# **Project Team**

PROVIDE 42" HIGH PHYSICAL BARRIER AT SLIDING GLASS DOOR TO PREVENT TENANT ACCESS TO EXTERIOR DURING

JECT NO.: 24-013

onstruction Plans, Sheet A1.1)

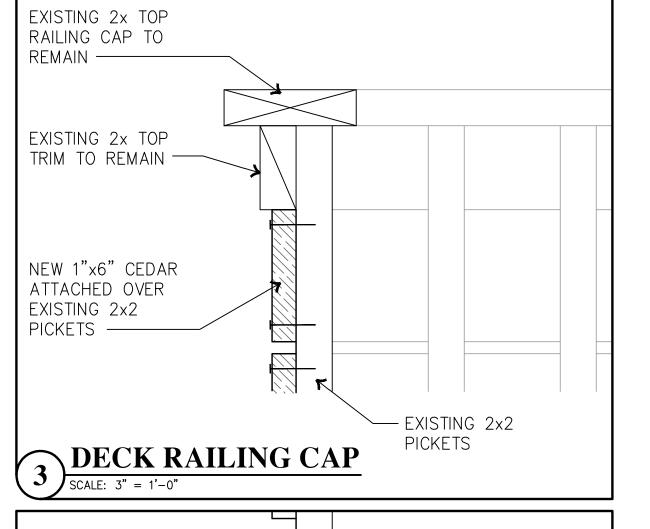
Provide specifics of the plywood that will be installed which should include plywood thickness, grade and any other specifics that will reflect that the plywood will withstand the dead and live loads of the deck. Identify the non-slip surface that will either be provided on the plywood or will be added to the plywood as part of construction, as notated on sheet A1.0, Owner/Contractor Coordination Notes.

The existing joist spacing should also be considered when selecting the plywood material that will be used. Please provide the existing joist spacing.

Determine the minimum required specifications for deck beams, posts, post bases, post caps and footings if replacements are necessary. Given the work already completed and the stop-work order in place, establish a clear benchmark to assess the completed work and provide clarity for future construction and inspection, minimizing any potential ambiguities.

Updated all details and notes as needed to reflect the requested information.

onstruction Plans, Sheet A1.1)

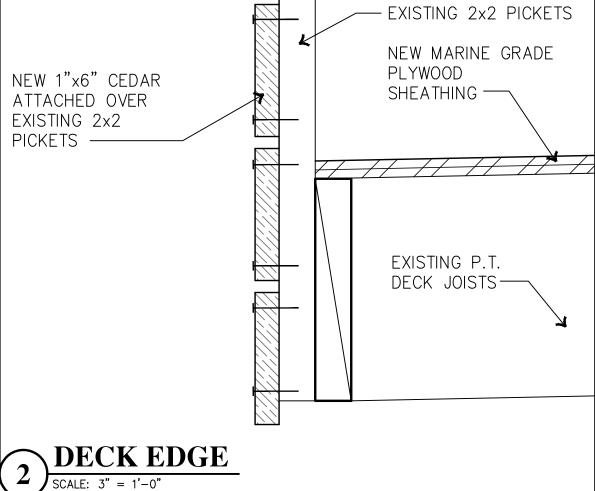
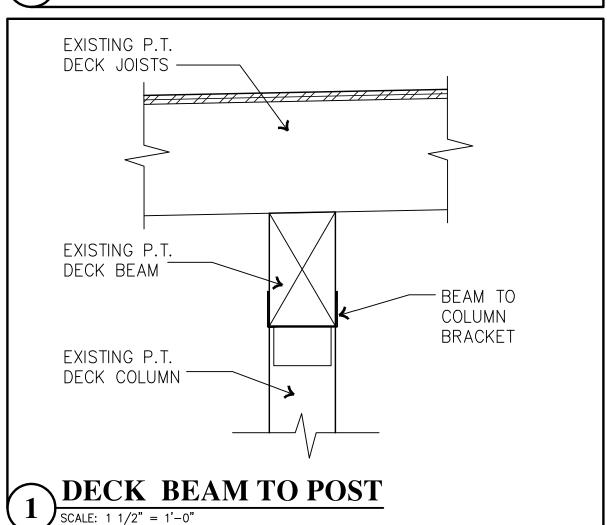
Deck joists appear to be sloped to drain off of the cantilevered side of each deck based upon details 1 and 2. Detail 2 shows the installation of the 1x6 cedar board over the existing 2x2 balusters. detail or notate how the 1x6 cedar will be installed to prevent drainage and water accumulation on the deck surface.

onstruction Plans, Sheet A1.1)

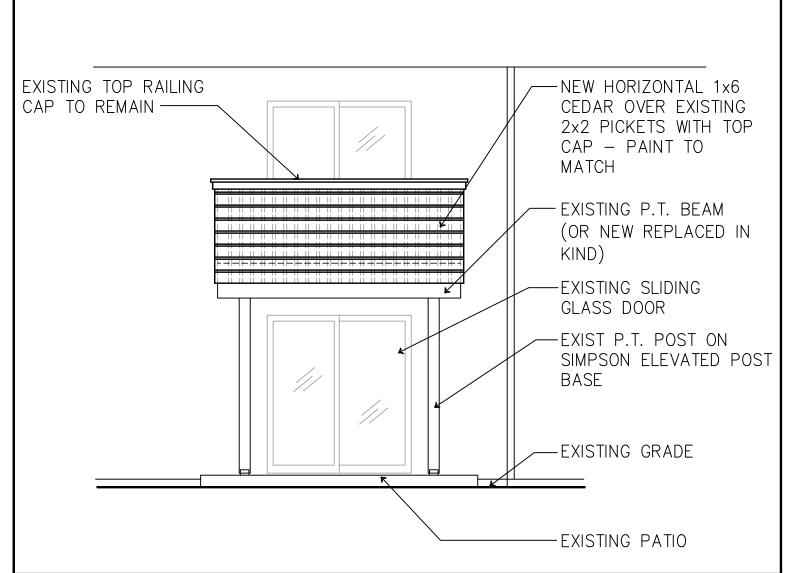
Add a notation on either Sheet A1.0 or A1.1 that contractor shall verify the integrity of balusters prior to the installation of the 1x6 cedar. Establish the parameters of the balusters replacement to include type, grade and nailing pattern.
